Studebaker

SERVICE BULLETIN

NO. 313

1956

FIG. 3

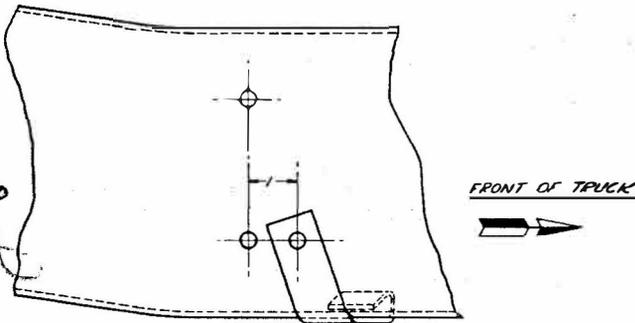
On trucks equipped with the Detroit Gear automatic transmission, the parking brake rear cable is located close to the oil cooler inlet pipe fitting.

As the engine mounts become more flexible, it is possible for an interference to develop between the brake cable and the pipe fitting. Since this fitting is under constant pressure with the engine running, a leak at this point could cause damage to the

transmission before the leak is discovered.

It is recommended that the parking brake rear cable guide on the right side of the chassis be moved forward 1 inch, (See Fig. 3), to eliminate the possibility of any interference between the cable and oil cooler fitting.

FIG. 4

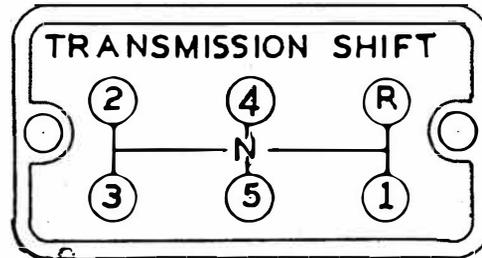
Trucks now being equipped with 5-speed transmission have an aluminum plate showing the shift sequence mounted on the instrument panel to the right and above the instruments.

The 5-speed direct transmission plate is shown in Fig. 4, and the 5-speed overdrive plate in Fig. 5.
